Town of Parker Community Development Department  
 Development Review Division  
 Attention: ~~Ashley Chasez~~ Amber Wood Hicken

Application Type: **Site Plan**  
 Status: **First Referral**  
 Application Name: Parker Pointe F1 AMD 1 L2A - McDonald's Site Plan  
 Case/AP#: **SP24-012**  
 Referral Received: March 18, 2024  
 Comments Due: April 15, 2024

Review date: **March 19, 2024**  
 Plan reviewer: **Randall L. Capra**, [rcapra@parkeronline.org](mailto:rcapra@parkeronline.org)  
 Phone: 303.805.3163

<b>TOWN OF PARKER FIRE/LIFE SAFETY:</b>	<b>R REVIEWED FOR CODE COMPLIANCE; REVISIONS REQUIRED</b>
---	---

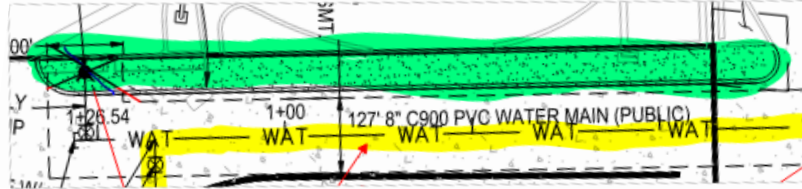
2. The access around the building (north side, is shown to be only 10 feet wide; it preapplication meetings, I believe that we had discussed a 15-foot drive aisle (possibly 14 foot?). In any case, ten feet is a bit too narrow. I would propose that the narrow landscape area to the north be minimized (reduced in width) and constructed as a raised rolled curb that is designed to withstand the weight bearing requirements of an 80,000-pound rig. Note the fire hydrant shall be relocated. *Satisfied; the applicant has addressed this issue with the second submittal. Note – the applicant has provided clarification and confirmed the required access through Wells Fargo.*

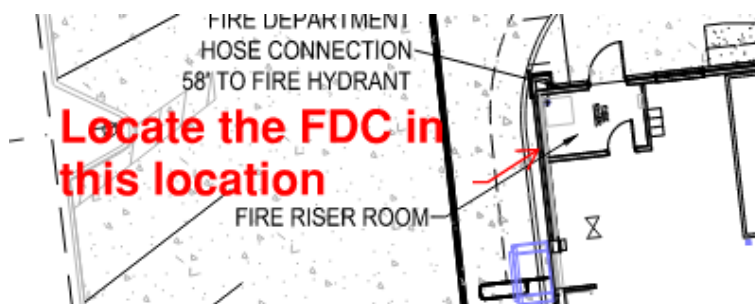
5. The FDC shall be located in the area of the riser room; see below for the location required for the FDC: *Not Satisfied; while the applicant has addressed this issue on the site plan, the utility drawings are showing the FDC on the east side of the building, south end. When resubmitting, clean up the drawings (all sheets) such that there is not apparent conflict.*

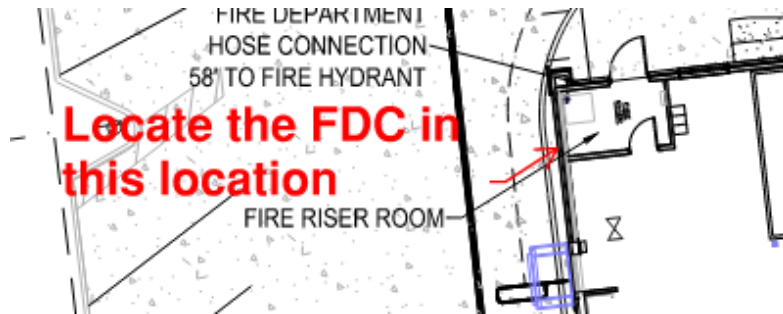
6. The applicant shall provide an auto turn analysis indicating that apparatus can navigate all portions of this site; NO PARKING – FIRE LANE signage is required for any portion of the access where the 20-foot clear width requirement cannot be met. In this case, the applicant has provided an auto turn analysis for a portion of the site; the applicant shall update the analysis to include the right in/right out entry on the south portion of the site; see below and address when resubmitting: *Satisfied; the applicant has addressed this issue with the second submittal.*

Note – the area identified with the two blue rectangles is of particular concern. People tend to not stay within the lines and the 20-foot drive aisle on the south end creates a potential for delays in response specific to staged or waiting vehicles in this area. Ensure that this issue is addressed adequately or provide signage that states **NO PARKING OR STANDING – FIRE LANE** in this area (area shown on west side of building... south end as well as the south side of the building).
